The following addendum supersedes information contained in the drawings and specifications issued of the project to the extent referenced. This Addendum forms part of the Tender Documents and is subject to all conditions set out in the contract documents

ELECTRICAL ADDENDUM E-02

Project title/Titre du projet
**ESQUIMALT GRAVING DOCK (EGD)
REPLACE MAIN DISTRIBUTION LINE (RMDL)**

**B.C. HYDRO (BCH)
POINT OF DELIVERY (POD)
SWITCHGEAR**

Drawing title/Titre du dessin
PLAN & PROFILE STATION 1+40 TO STATION 2+30

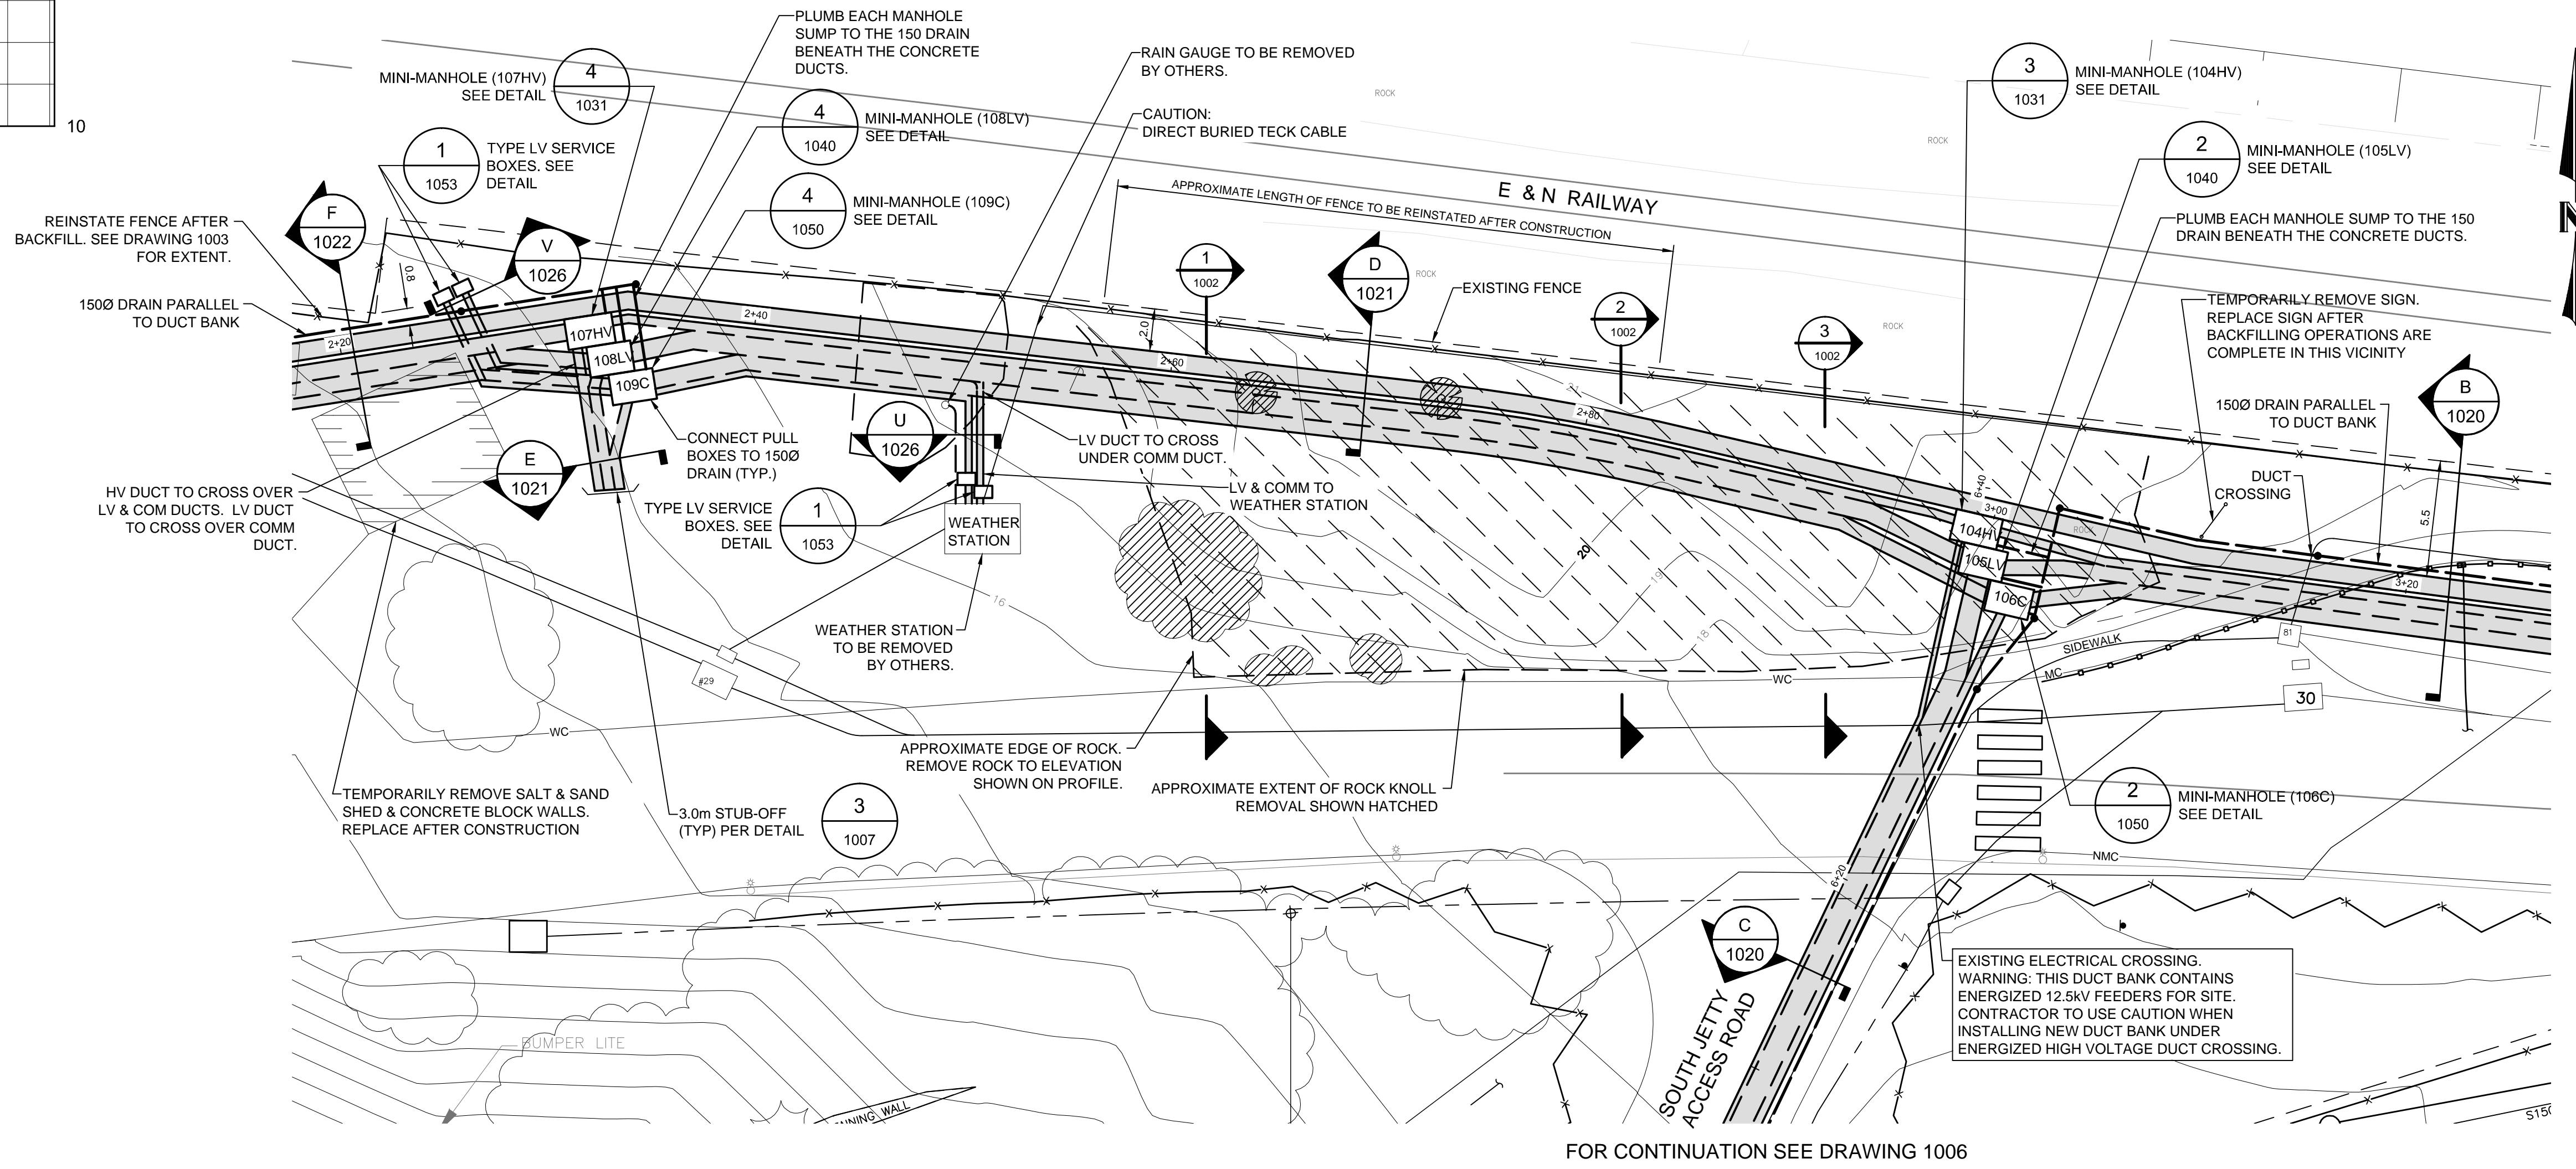
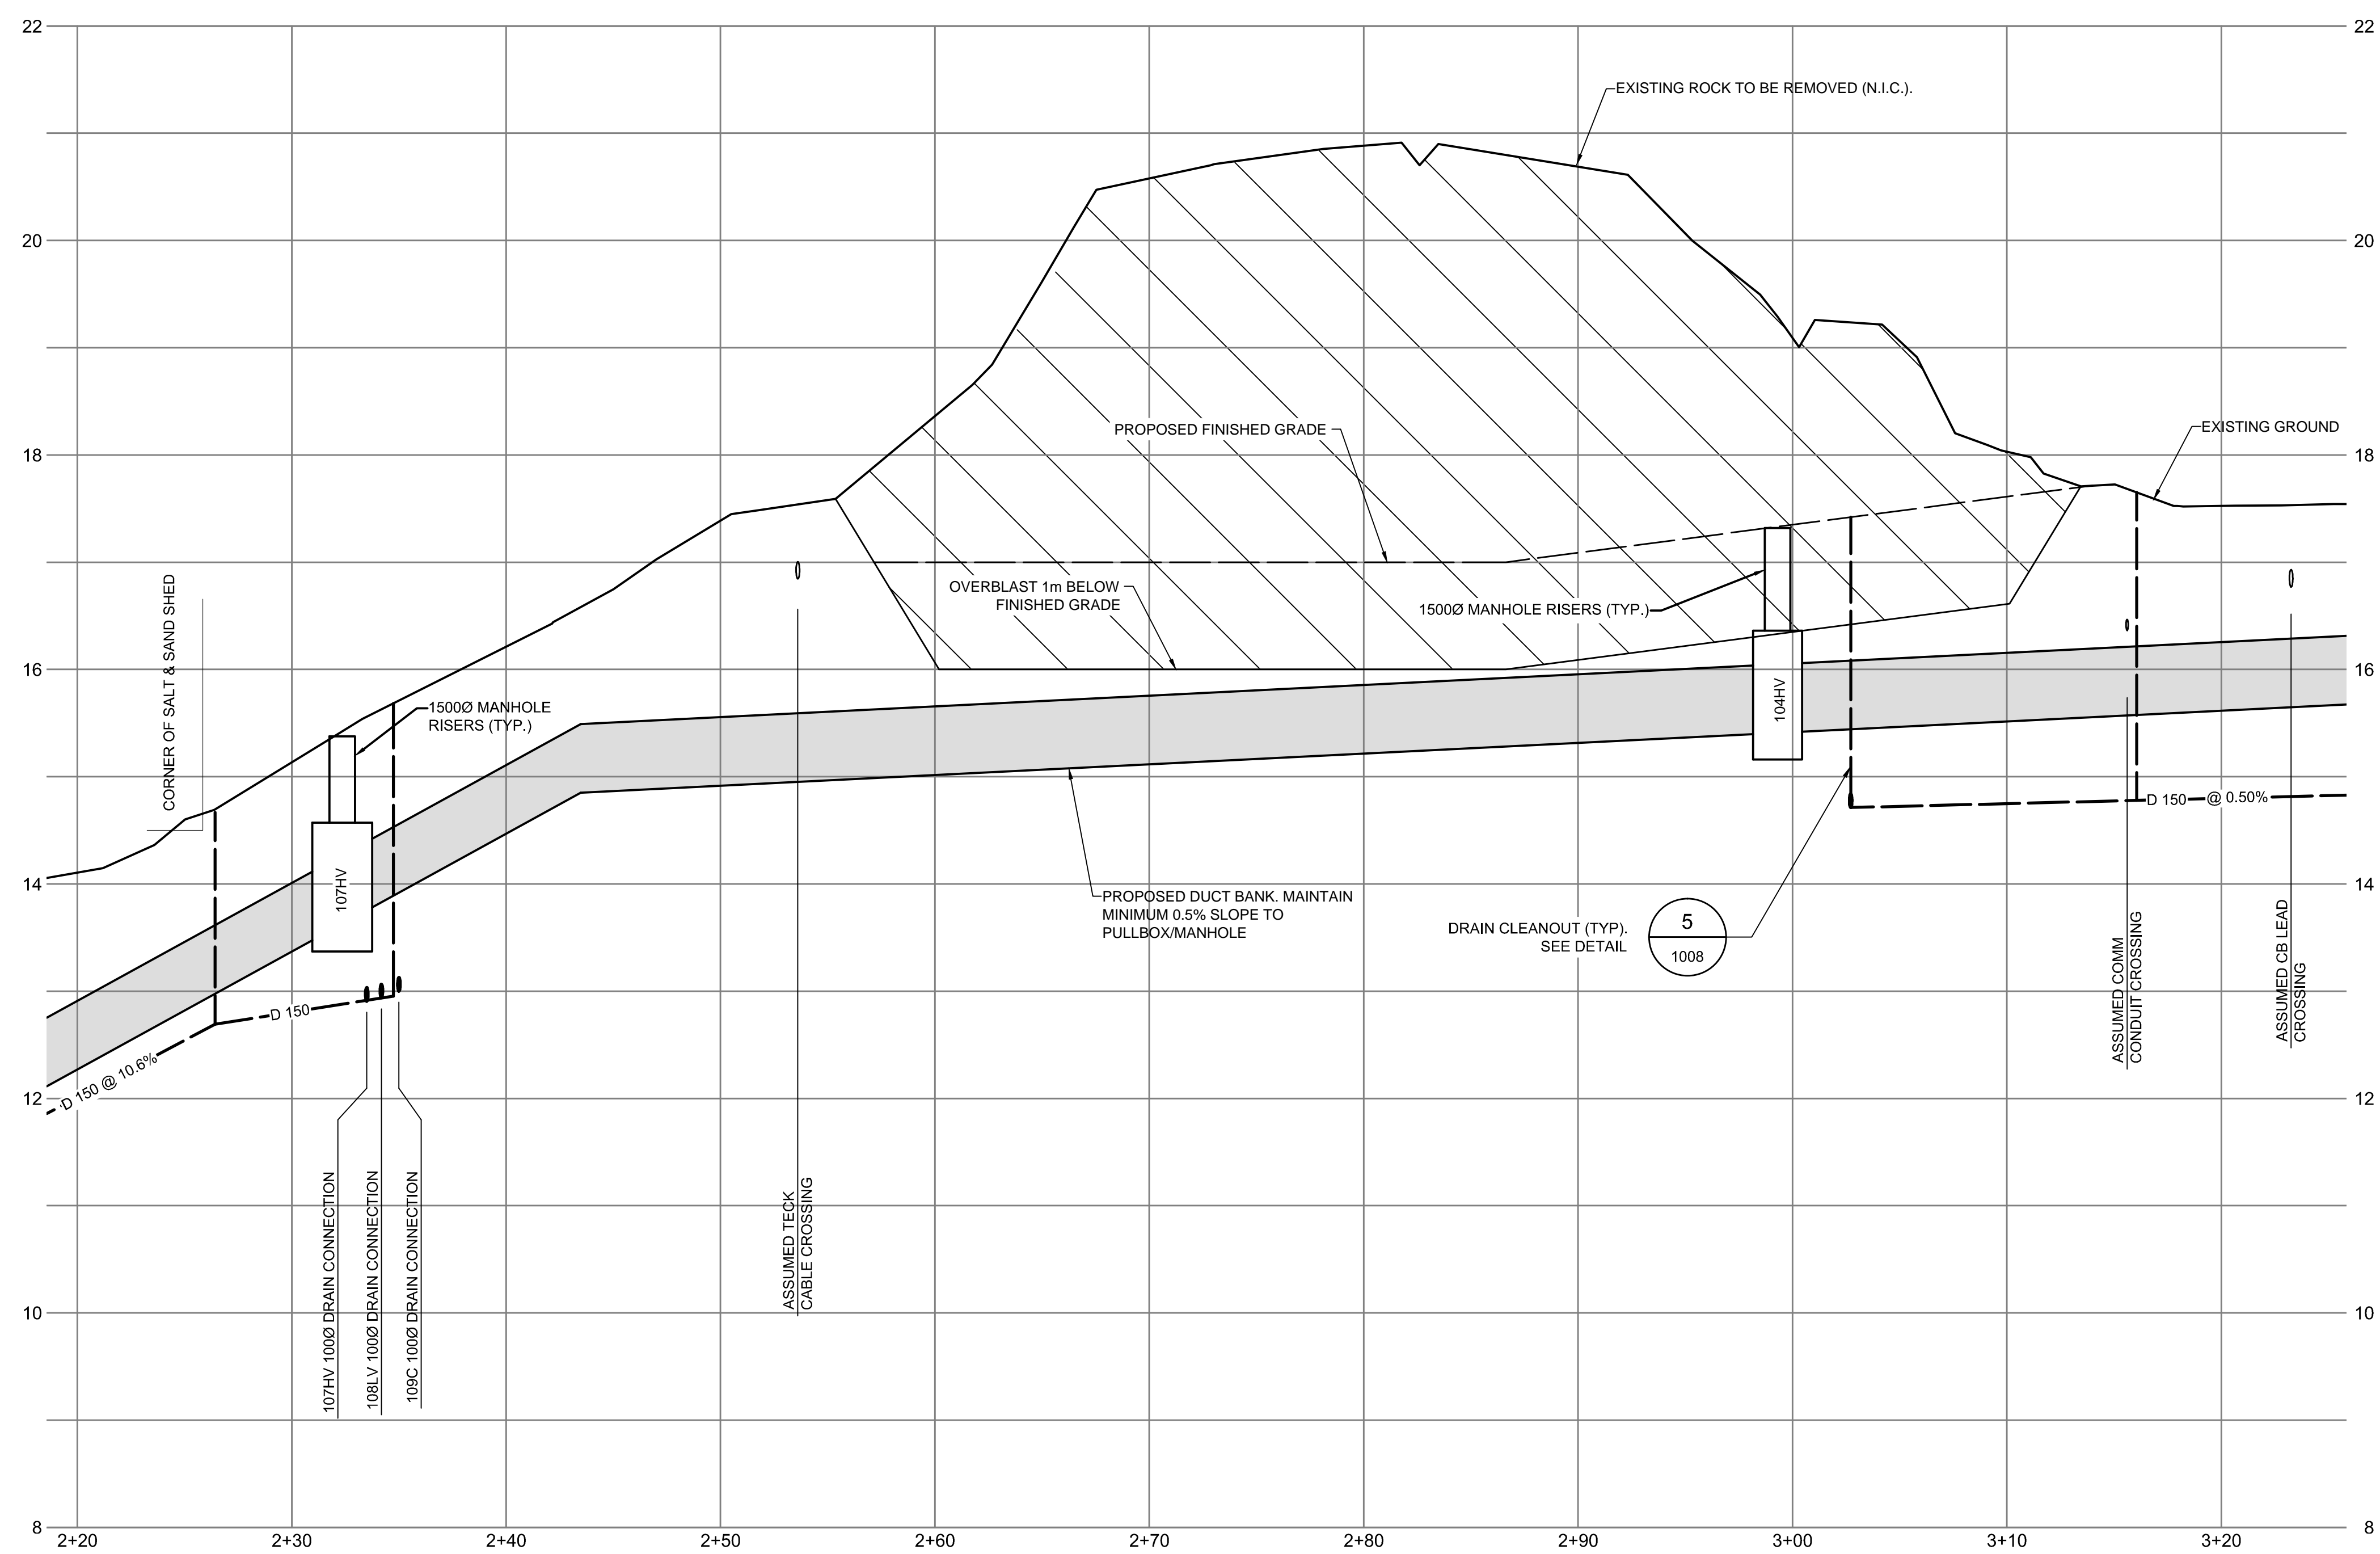
Q: Please issue a site plan showing the location of the SES building in reference to the BCH switch.

A: A basic site plan shall be provided and attached to this addendum. Refer to attached drawings “Service Entrance Substation (SES) & Pump House Substation (PHS)” drawing 1000, 1001, 1002 and 1003.
